LANDING GEAR - PARKING BRAKE ASSEMBLY INSPECTION

680

-0584 thru -0589

SL680-32-17
Page 1 of 4

Figure 1. Parking Brake Cable Installation (Sheet 1)

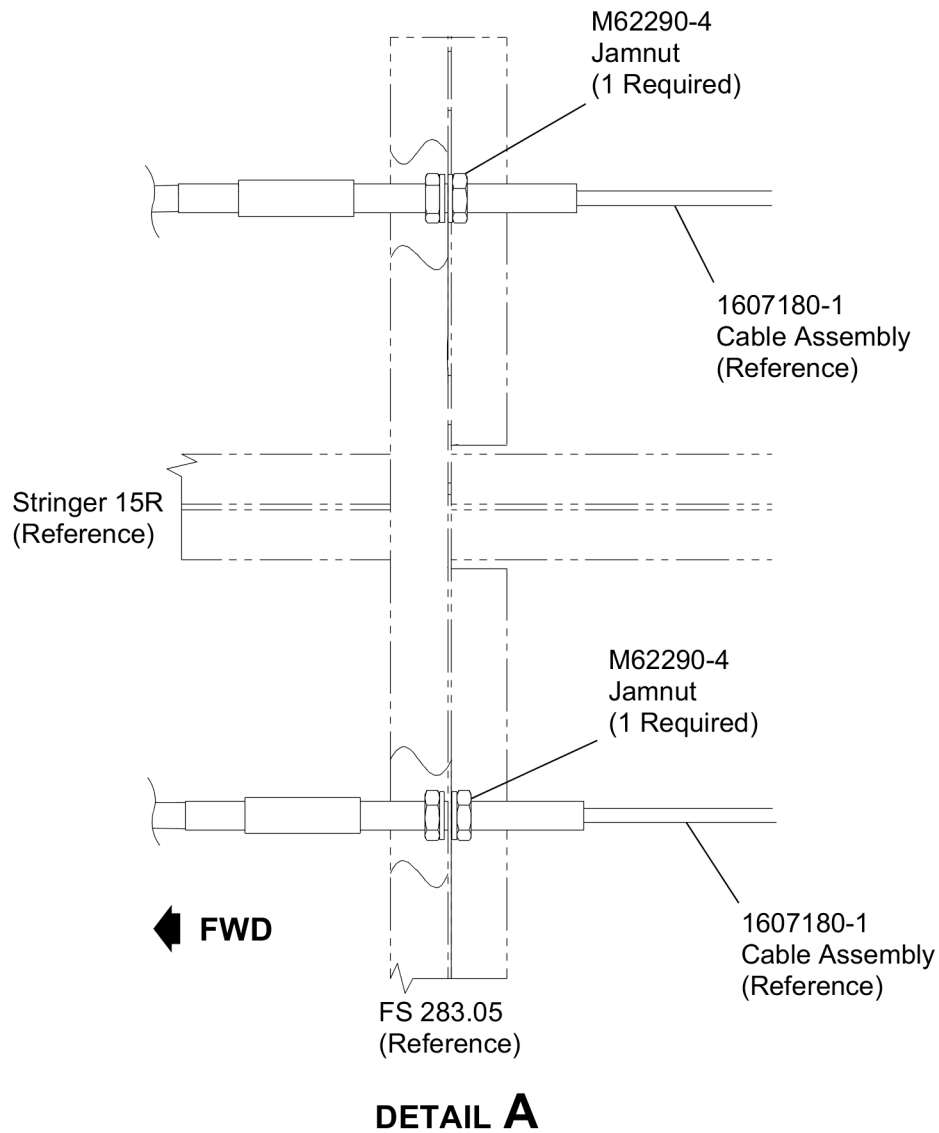
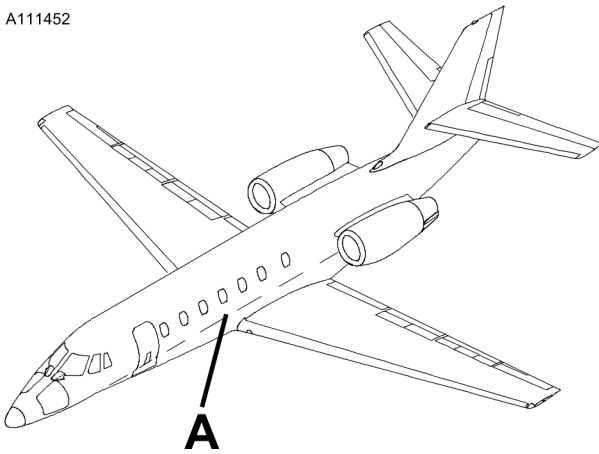
- D. (Refer to Figure 1, Sheet 1.) Disconnect the 1607180-1 Brake Cable Assemblies from the aft side of the frame at fuselage station 283.05.
 - E. Install the missing M62290-4 Jamnuts on the 1607180-1 Cable Assemblies.

- F. Connect the 1607180-1 Brake Cable Assemblies and torque the M62290-4 Jamnuts to 35-40 inch-pounds. (Refer to the Citation Standard Maintenance Practices, Chapter 20, Torque Data - Maintenance Practices.)

- G. Safety wire the M62290-4 Jamnuts. (Refer to the Citation Standard Maintenance Practices, Chapter 20 Safetying - Maintenance Practices.)
 - H. Do a functional check of the parking brake system. (Refer to the Model 680 Maintenance Manual, Chapter 32, Power Brake and Antiskid System - Inspection/Check.)
